City of Bellevue
Department of Planning and Community Development
Development Services Staff Report

Proposal Name: Lower Coal Creek Sediment Pond

Proposal Description: Application for Critical Areas Land Use Permit to construct an in-stream sediment pond with the capacity to capture 1,500 cubic yards of sediment per year in Coal Creek, a Type F stream. This project is part of a larger effort to control sediment erosion, transport, and deposition resulting from past coal mining and other watershed activities. Proposed work is part of the Coal Creek Stabilization Program which was reviewed under a programmatic Final EIS under file #05-117838 LE.

File Number: 07-132603 LO

MITIGATION REPORT SHEET

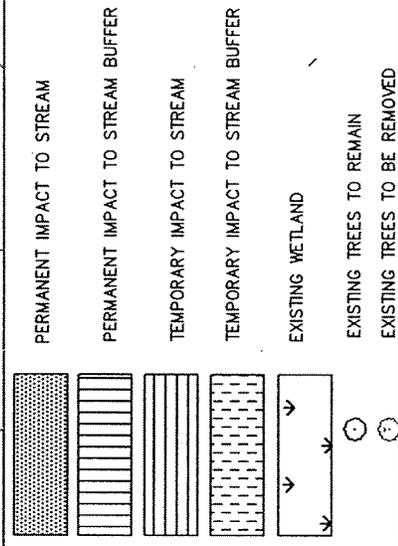
A third contingency regarding the loss of vegetation based on wildlife damage is not supportable as it would potentially require fencing, the use of repellants, and temporary barriers inconsistent with other aspects of this approval. The contingency plan must be modified to amend the 3rd contingency.
